RE: COTTONWOOD PROFESSIONAL CENTER PHASE 2 (B-14/D3)
(1640 Alameda Blvd NW)
ENGINEERS CERTIFICATION FOR CERTIFICATE OF OCCUPANCY
ENGINEERS STAMP DATED 7/19/2002
ENGINEERS CERTIFICATION DATED 2/7/2003

COTTONWOOD PROFESSIONAL CENTER - PHASE II GRADING PLAN

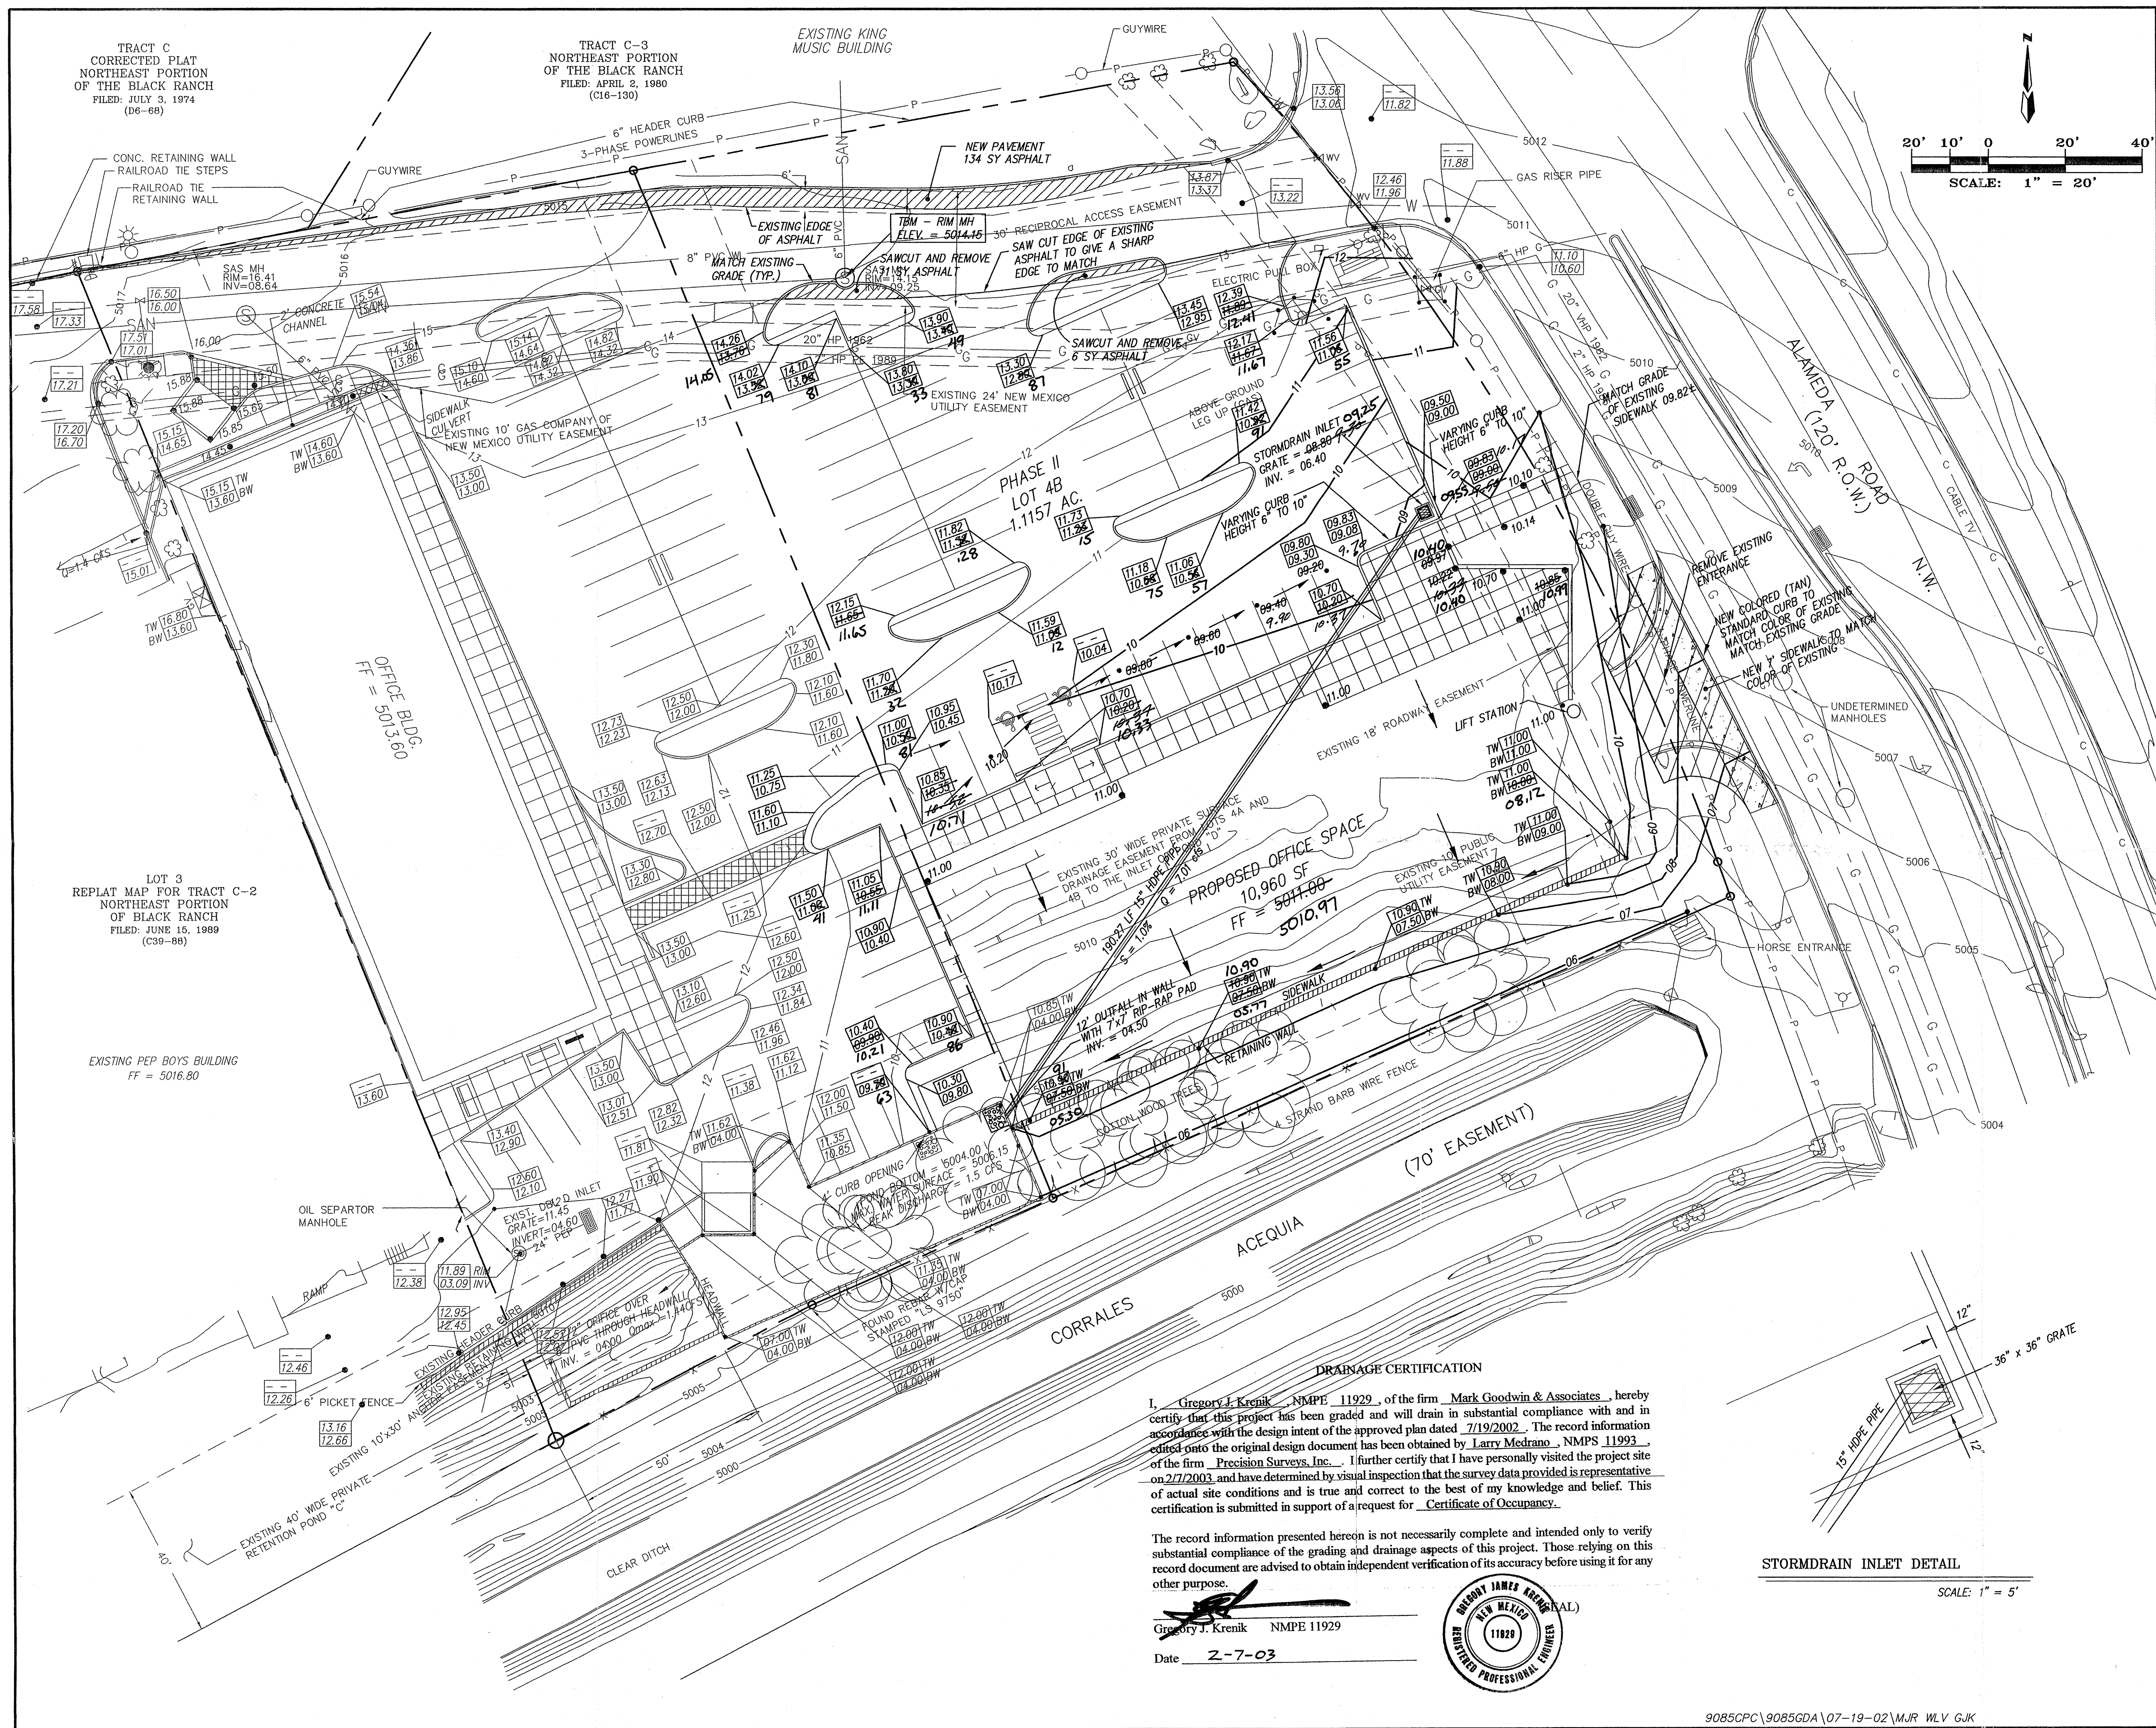
Based upon the information provided in your Engineers Certification submittal dated 2/7/2003, the above referenced site is approved for a Permanent Certificate of Occupancy for Phase 2.
